APPLICATION OF TEXAS UTILITIES  
GENERATING COMPANY, ET AL. FOR  
AN OPERATING LICENSE FOR  
COMANCHE PEAK STEAM ELECTRIC  
STATION UNITS #1 AND #2  
(CPSES)

Docket Nos. 50-445  
and 50-446

AFFIDAVIT OF MARK A. WALSH

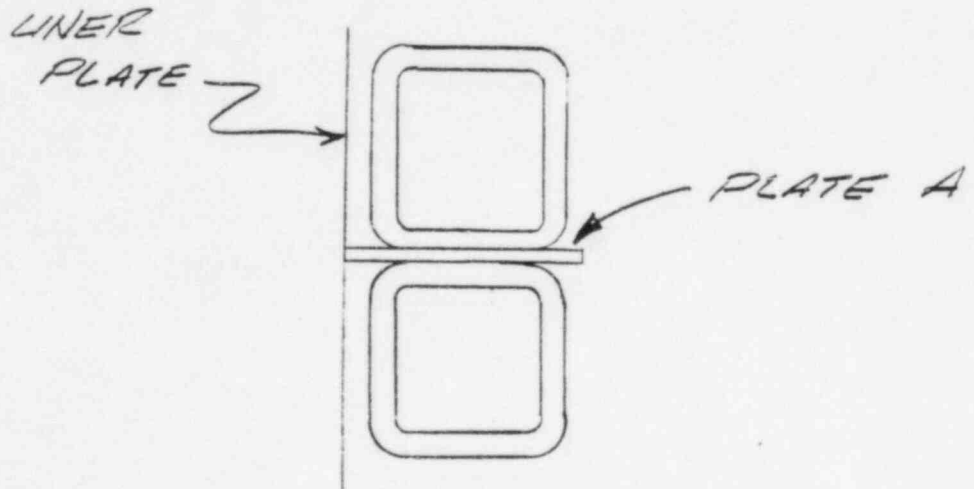
20 To illustrate, referring to Attachment A to my affidavit, which  
21 I have prepared, Figure 1 is the cross-section of a tube steel section with-  
22 out the hole drilled in it. Its properties for a TS 4x4x1/2 are: Area =  
23 6.14 in.<sup>2</sup>; moment of inertia = 11.4 in.<sup>4</sup>; and section modulus of 5.7 in.<sup>3</sup>  
24 (using 7th Edition steel properties).

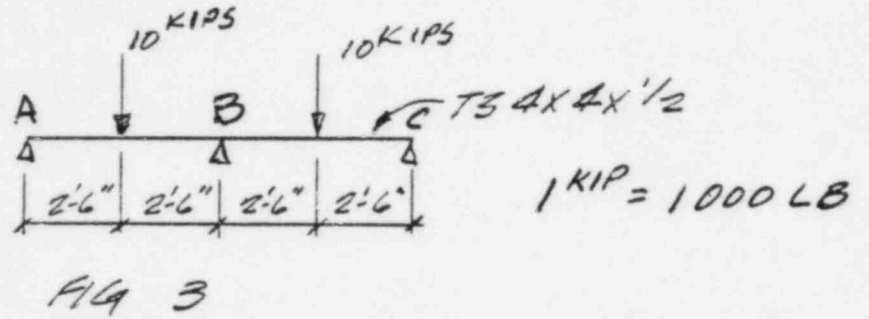
25 In Figure 2 of the Attachment is the same tube steel shape, but

1 at the Richmond insert where a 1-5/8" diameter hole has been drilled to  
2 accommodate the threaded rod, its properties are as follows: Area = 6.14  
3  $-(2)(1/2)(1-5/8) = 4.52 \text{ in.}^2$ ; moment of inertia  $\approx 11.4 -(2)(1/2)(1.625)(1.75)^2$   
4  $= 6.423 \text{ in.}^4$ ; and the section modulus is  $6.423/2 = 3.211 \text{ in.}^3$ .

5 It is apparent that there is a reduction in properties at the connection  
6 of a Richmond insert. The most significant reduction is that of the section  
7 modulus. To illustrate this problem, see Figure 3 of Attachment A. This  
8 is a 2 span continuous beam with two concentrated loads with dimensions  
9 as shown. The moment in the beam at support point B is  $(3/16)(10)(5) =$   
10  $9.375 \text{ kip-ft}$ . The bending stress, using a full tube steel section modulus  
11 is  $(9.375)(12)/5.7 = 19.7 \text{ ksi}$  at support point B.

12 The bending stress in the tube steel using the actual section modulus  
13 at support point B is  $(9.375)(12)/3.211 = 35 \text{ ksi}$ . The allowable bending  
14 stress for A500 Grade B tube steel is  $(.67)(36) = 24 \text{ ksi}$ . Therefore, this  
15 member would be highly overstressed.

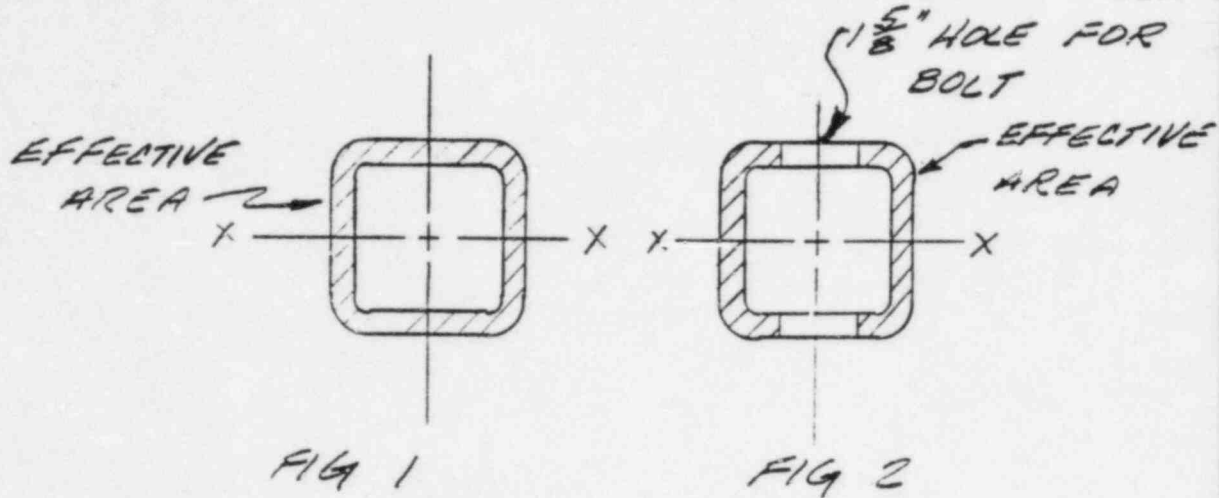
16  
17 Another item I have not previously mentioned is overstressed liner  
18 plate attachments. NPSI has attached to the liner plate with an assembly  
19 similar to what is shown in Figure 4. Plate A is the member that is being  
20 overstressed. I became aware of this problem about Decmeber 1981 or January  
21 1982. I informed the NPSI group that plate A had a bending stress of 60 ksi  
22 when analyzed with normal operating loads, and returned the support package  
23 back to them.

24 One month later, the same support package came to the STRUDL group  
25 to be reanalyzed. I once again informed NPSI of the overstressed plate.

1 This time I was instructed not to model in the plate. I was told that the  
2 plate was not NPSI's but Gibbs & Hill's responsibility, and that Gibbs &  
3 Hill had accepted it although NPSI knew it was overstressed.
